MISO IMM Comments on LRTP Tranche 2 Benefit Analysis

MISO Independent Market Monitor

October 30, 2024

Siting is Critical to Accurately Calculate Benefits: Fundamental Flaw in MISO's Analysis

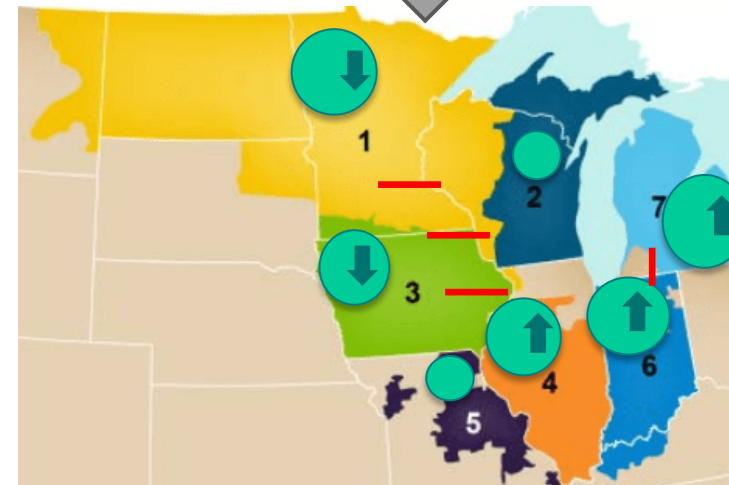
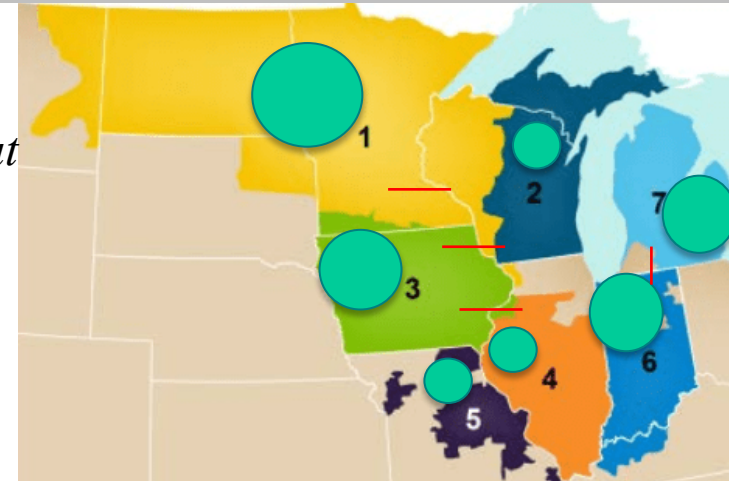
- Any accurate benefit-cost analysis must compare expected outcomes *with & without* the factor studied (i.e., Tranche 2 projects)
- MISO assumes large quantities of resource development in areas that would utilize the Tranche 2.1 facilities

- Without Tranche 2.1, changes in energy and capacity market signals/requirements would shift resources closer to load
- MISO ignores this – assuming Tranche 2.1 will have no effect on resource investment
- This is a major flaw because these siting changes would shift, reduce or eliminate many of the categories of benefits

Categories of Benefits Estimated by MISO

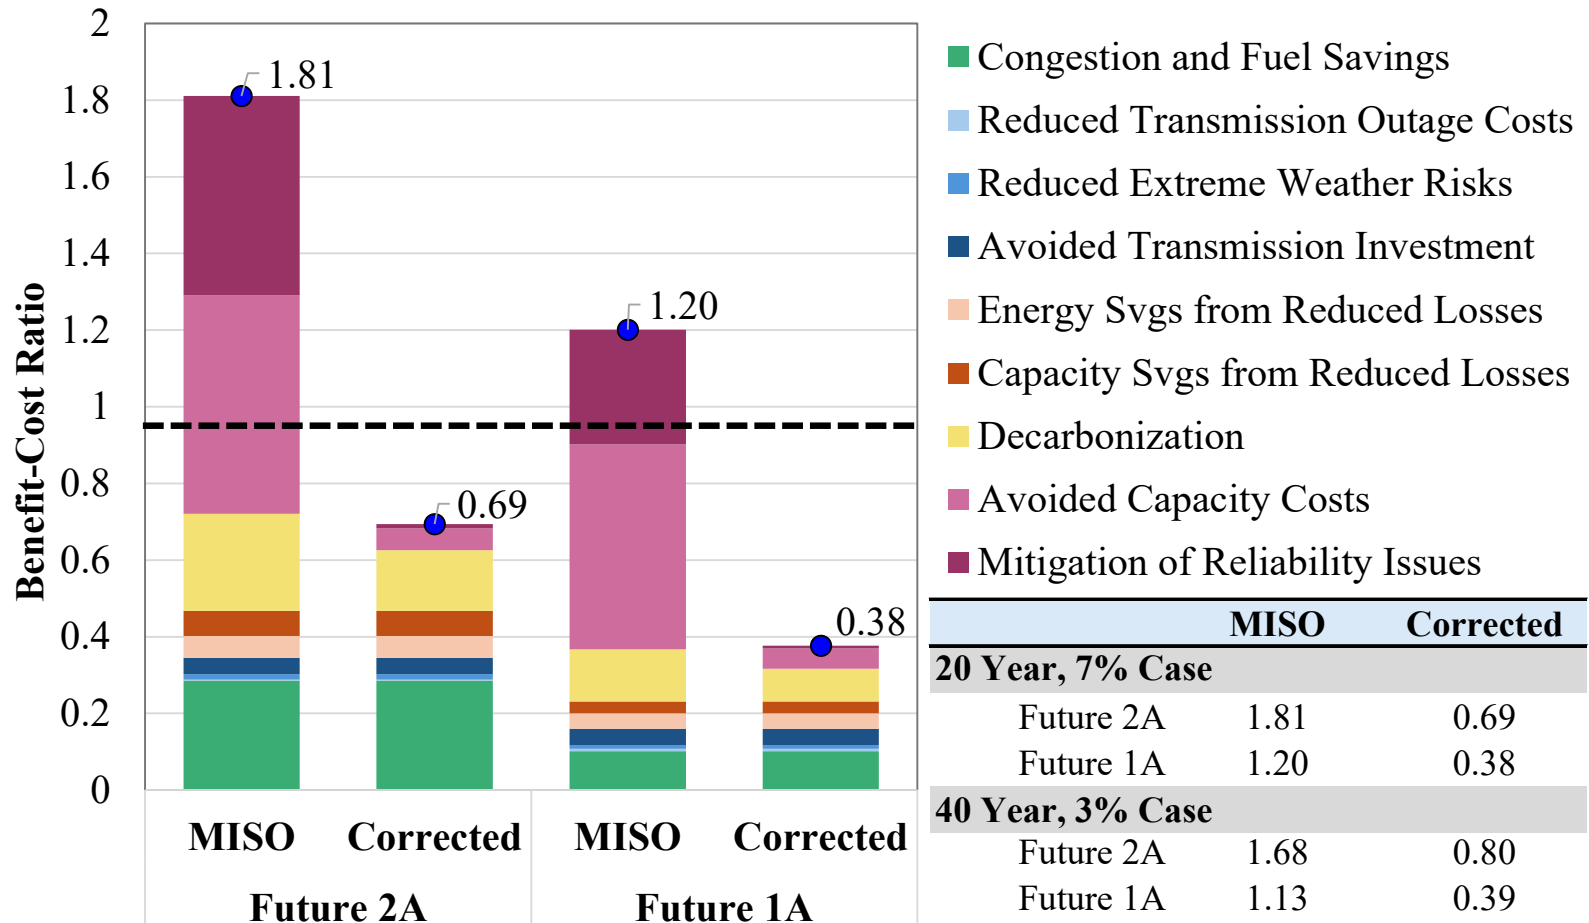
- The primary source of economic benefits - overstated by siting flaw
- Overstated by siting flaw – shifting resources closer to load will lower losses, reducing these benefits
- Overstated by not assuming a reasonable range of carbon values
- Valid category of benefits – not captured by most models
- Valid category of benefits
- Valid category of benefits
- Overstated by siting flaw
- Invalid methodology

Summary of Benefit-Cost Results: 20-Year, 7% Discount Rate Case

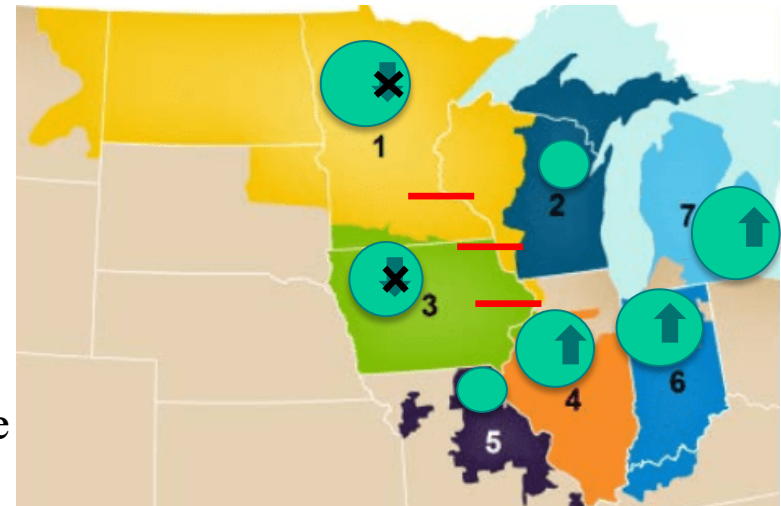
- ✓ Although the siting flaw described above inflates every category of benefits, our corrections only address the two largest categories
 - ✓ The economic benefits of reducing congestion costs, including the costs of outages and extreme weather, produce benefit-cost ratios ranging from 0.11 in Future 1A and 0.3 in Future 2A

- ✓ Adding the benefits associated with reduced losses, which are overstated because of the siting flaw, as well as the decarbonization benefits valued at the level of the renewable subsidies, raises the ratios to 0.27-0.58

- ✓ Finally, when the two largest categories are corrected, the final benefit-cost ratios range from 0.38 in Future 1A to 0.69 in Future 2A
- The 40-year, low discount rate case yields similar results with corrected benefit cost ratios ranging from 0.42 in Future 1A to 0.83 in Future 2A

* MISO cases show the minimum value, affecting only 2 benefits by excluding the high-end carbon value and VOLL.
